ADDENDUM #4

Renovation to the Old Detention Center for the Transylvania County Board of Elections Offices, Brevard, North Carolina

Addendum #4 **May 15, 2015**

This addendum supersedes all other addenda and forms a part of the bid documents and modifies the original project manual and drawings dated March 23, 2015.

SHEET ADD4-1

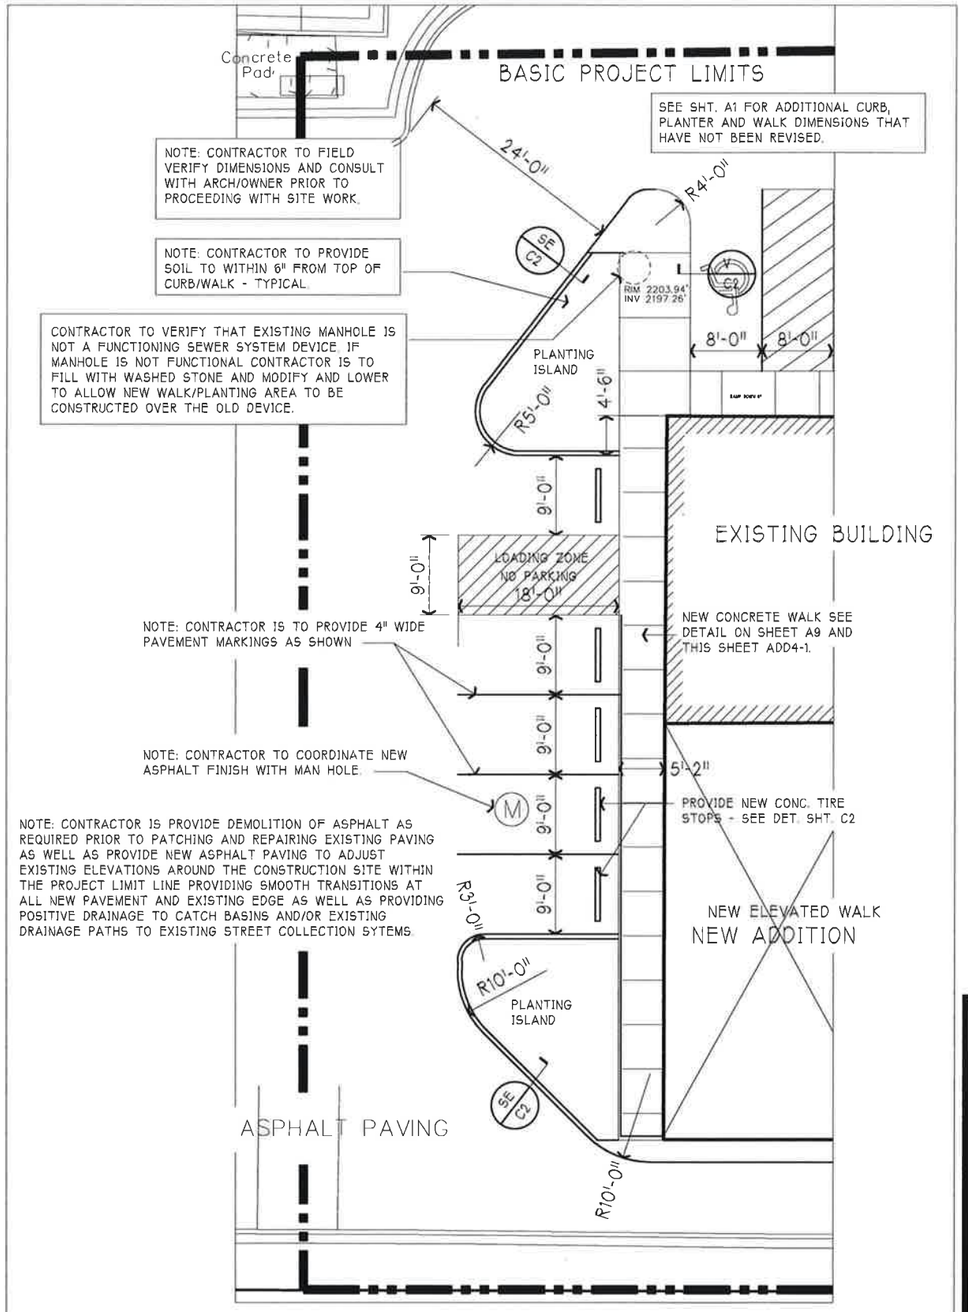
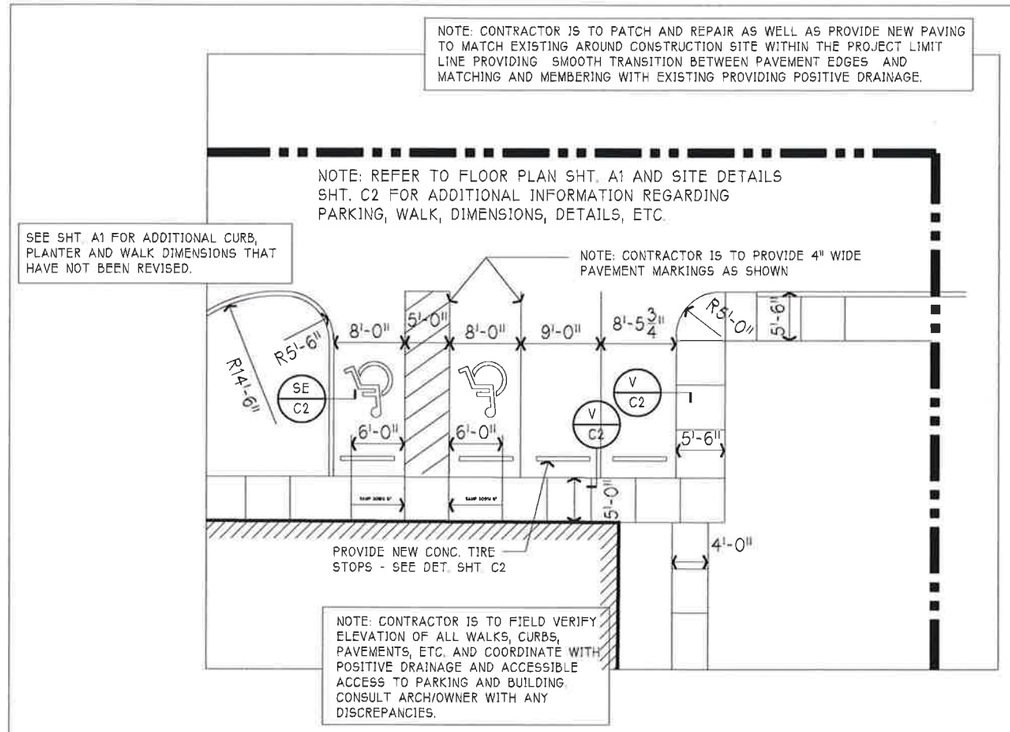
A. Parking Layout at West and North East sides of building to be revised in accordance with Attached drawing Sheet ADD4-1 dated May 13, 2015 including new curbed planting islands and revised handicap parking spaces. Basic Project limits have been adjusted to accommodate this additional work. This drawing will also revise specific parking areas shown on Sheets LS and A1. Drawing sheet is to be plotted as an 11"x17" sheet.

A. Asphalt demolition and site work is defined within the dotted line indicated as Basic Project Limits on Sheet C1. Please refer to the attached drawing ADD4-1 which slightly increases the area of Limits. It is also noted that the 12" undercut for top soil that has been used on other County Projects is not required on this project.

SHEET ADD4-2

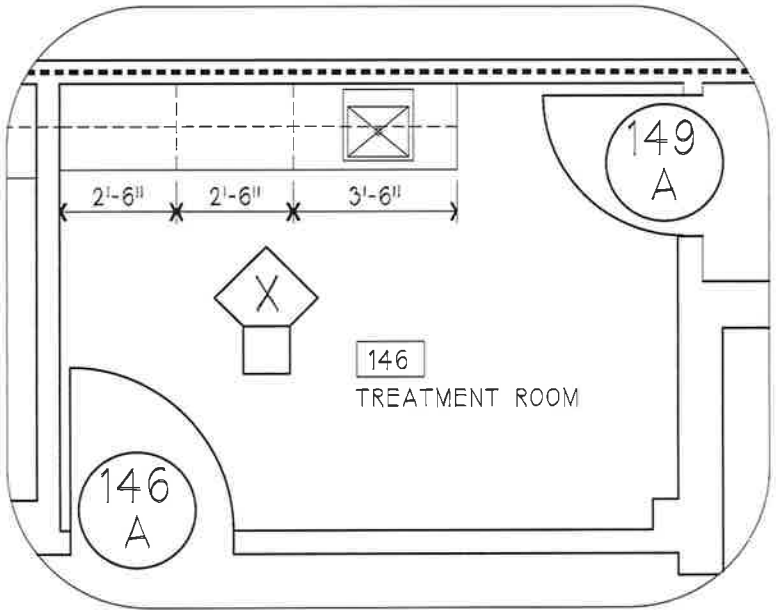
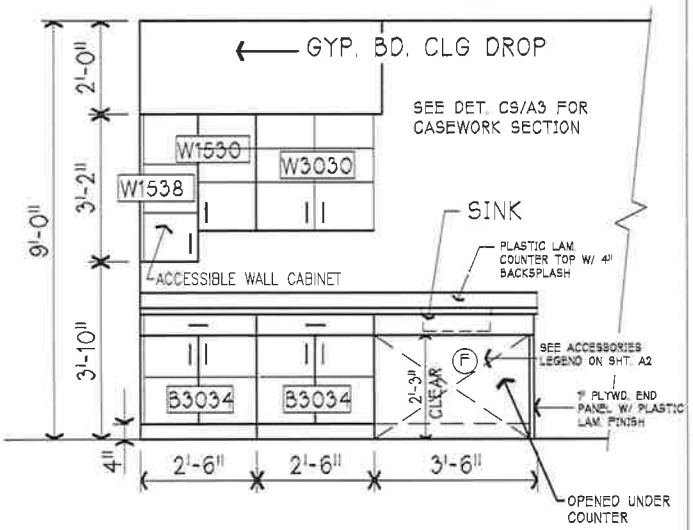
A. 8" Carpet Base noted on Elevations "F" & "G" is limited to these two elevations and is to match carpet selecting for floor in adjacent space.
B. See Attached Sheet ADD4-2 for casework plan and elevation for Treatment Room #146.

1 / M101 PROPOSED PLAN – HVAC

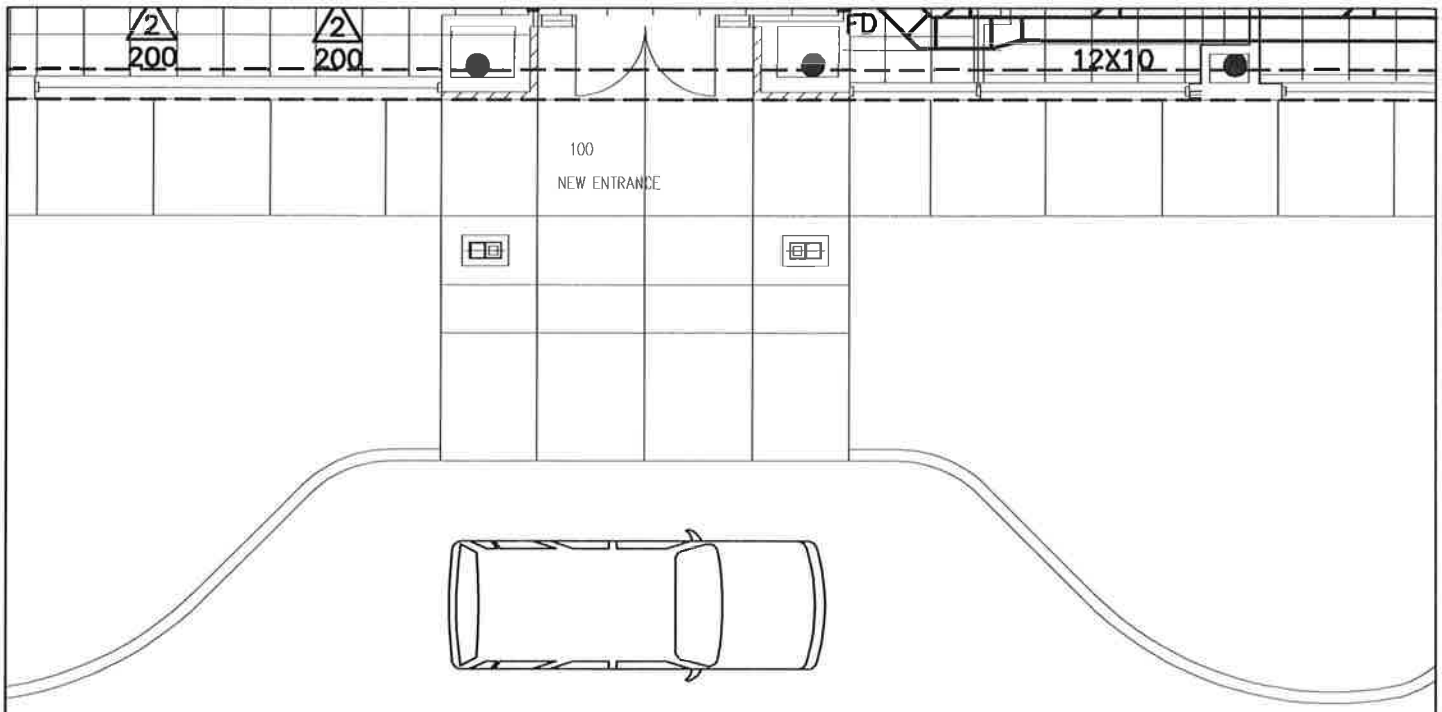
A. Revise Sheet M101 in accordance with Attached drawings Sheet 1/M101 and 2/M101 dated May 1, 2015. Drawing sheets to be plotted as an 81/2"x11" sheet.
